ADA Curb Ramp New Construction Inspection Form (Perpendicular)

Nw 291 ave

23885.56

Nw fair st

PERPENDICULAR RAMP (PR)

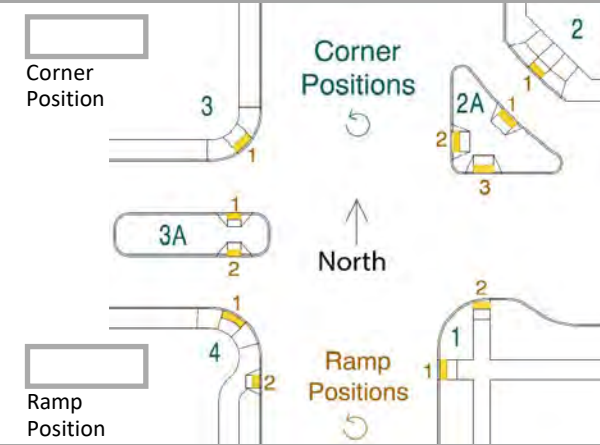
Turn space less than 4 ft clear width
